**Development Permit Panel**

**2. **Development Permit 12-615584****

**3. **Development Permit 13-630413****

4. **Development Permit 13-636863**  
(File Ref. No.: DP 13-636863) (REDMS No. 3980127)

**DRAWING TITLE**  
ELEVATIONS

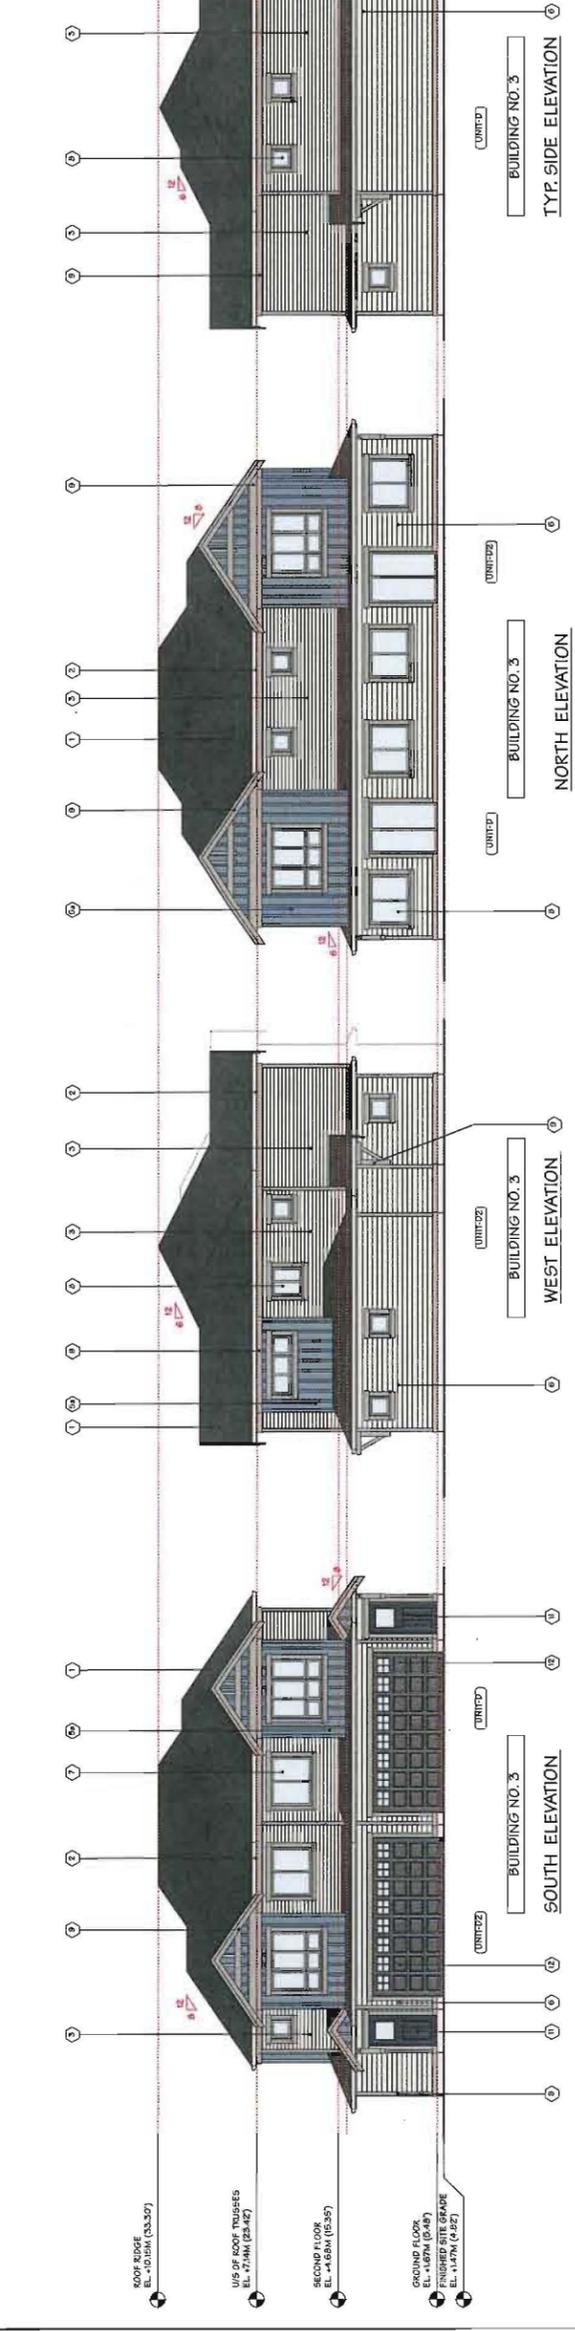
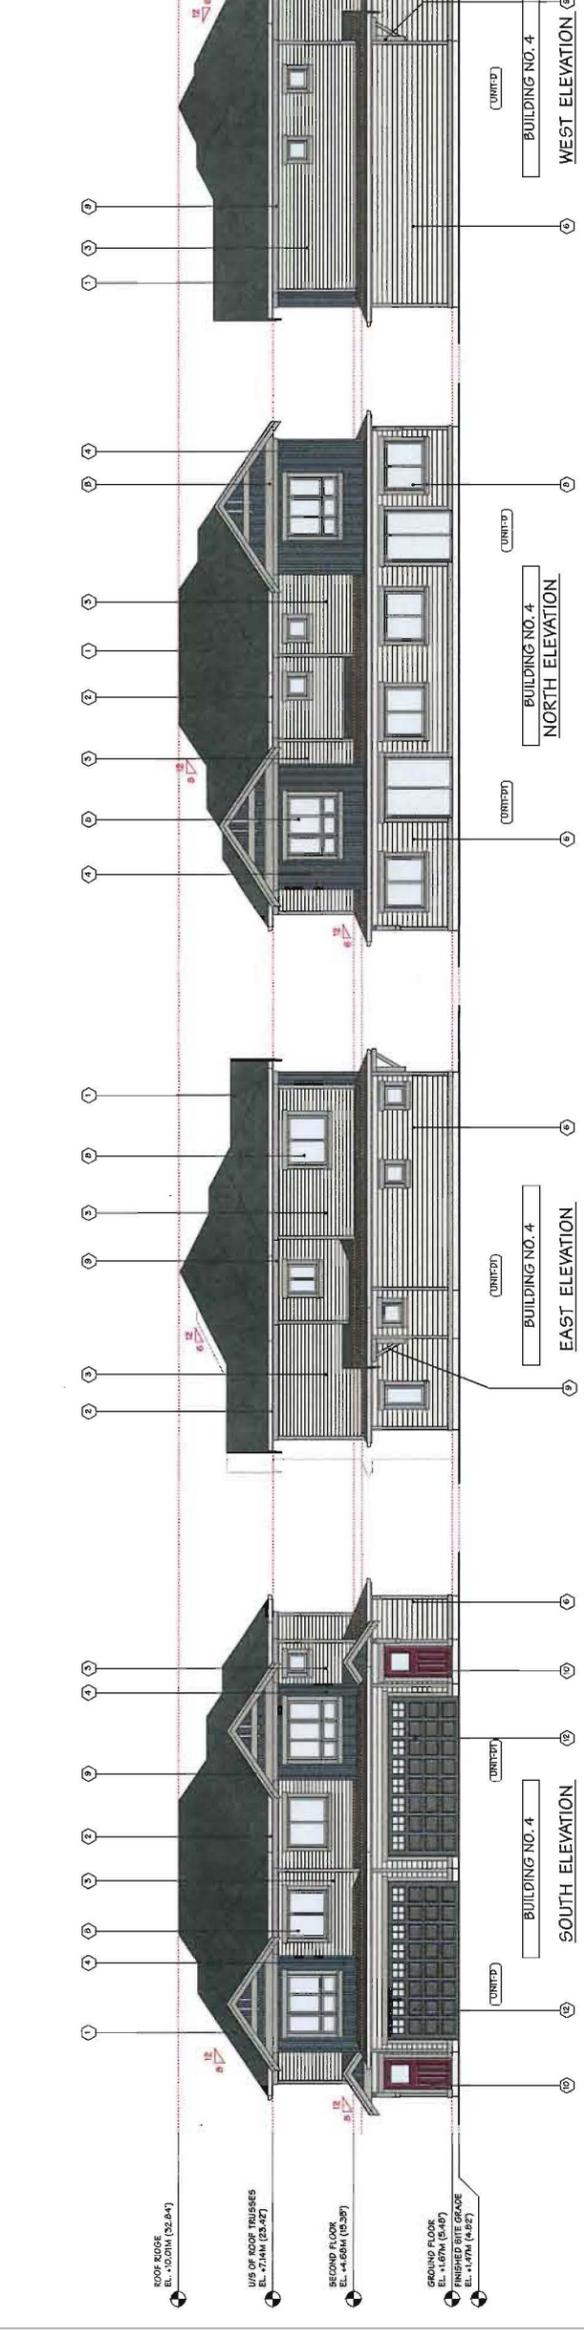
***Noted.***
11. dark coloured materials appear drab; consider a lighter colour scheme to lighten the massing of the buildings;  
***Lighter color scheme revisited to emphasize the massing of the buildings. See revised colored elevations and material/color board. See sheet A4.1/4.2.***
